Agenda Item # 4

SUB-003205-2025

Resubdivision of Lot 4, Block B of Sunset Hills, 2nd
Addition

APPLICATION NUMBER 4 DATE February 20, 2025

DETAIL SITE PLAN

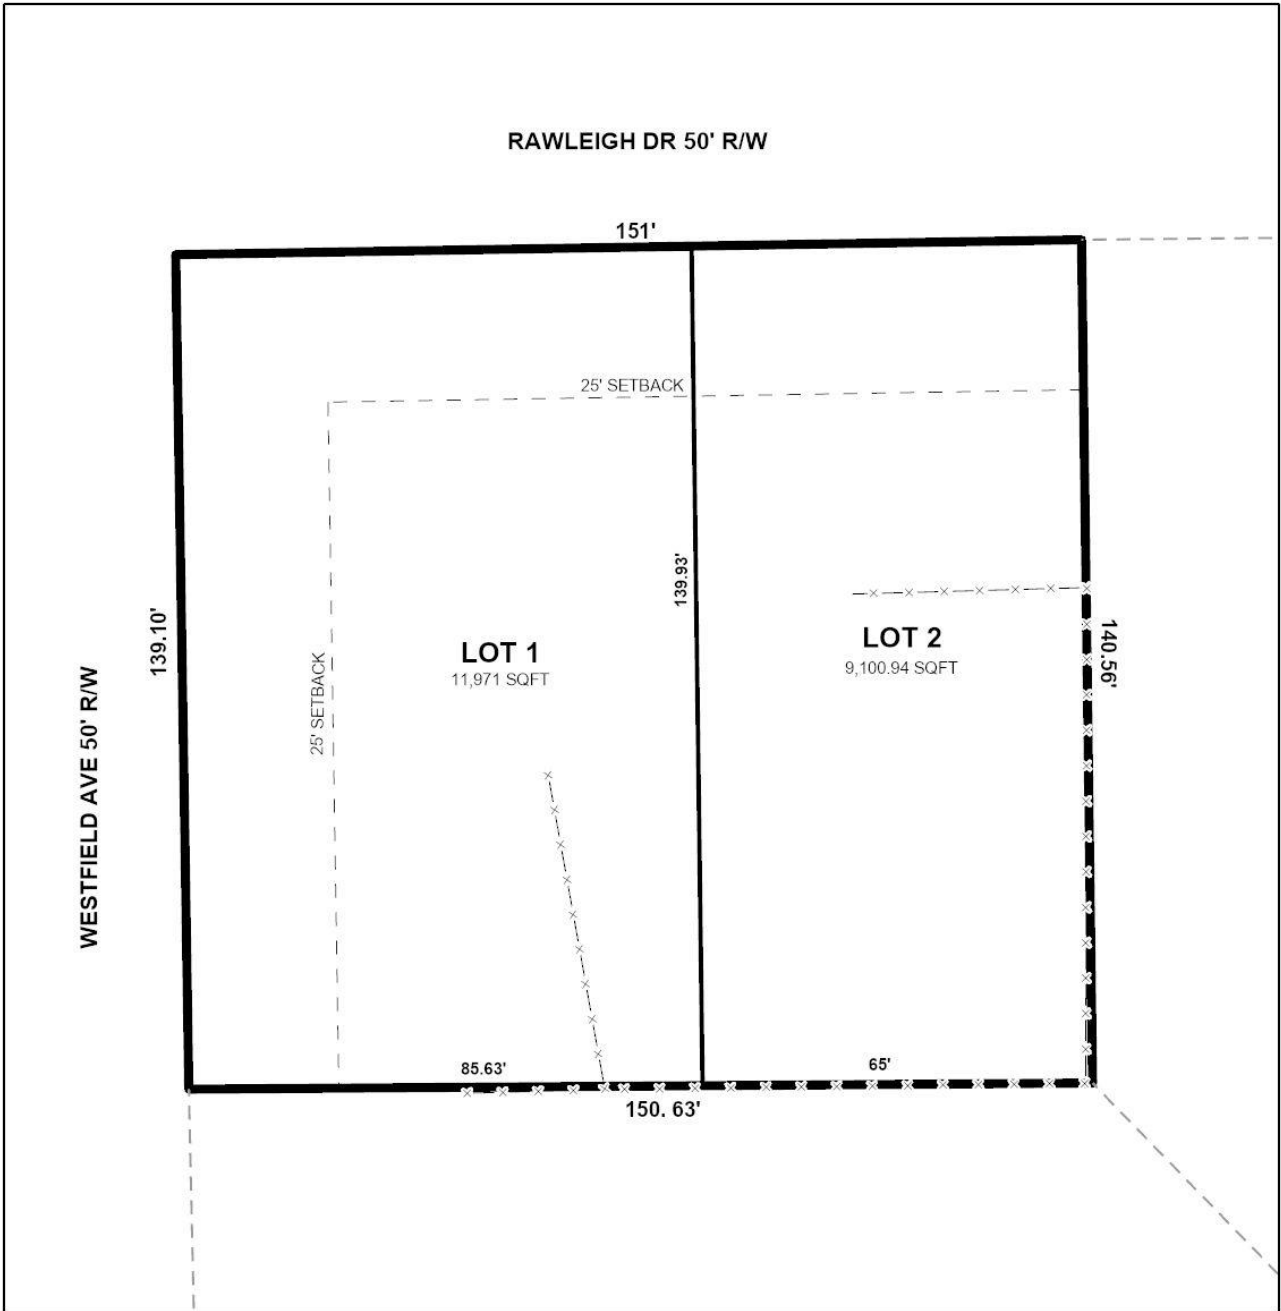
- B. Dedicate the corner radius (25' minimum or as approved by the City Engineer and Traffic Engineer) at the northeast corner of LOT 1 to the City of Mobile, and list the amount of dedicated acreage (square feet and acres).

Lot 1 is a corner lot requiring a 25-foot radius (or as approved by the City Engineer and the Traffic Engineering Director) where Westfield Avenue and Rawleigh Drive intersect, per Section 6.C.6. of the Subdivision Regulations. Revision of the plat to depict sufficient dedication of the corner radius should be required, if approved.

1. Retention of the 50-foot right-of-way widths along Westfield Avenue and Rawleigh Drive on the Final Plat;
2. Revision of the plat to illustrate dedication of a 25-foot corner radius at the intersection of Westfield Avenue and Rawleigh Drive, per Section 6.C.6. (or as approved by the City Engineer and the Traffic Engineering Director);
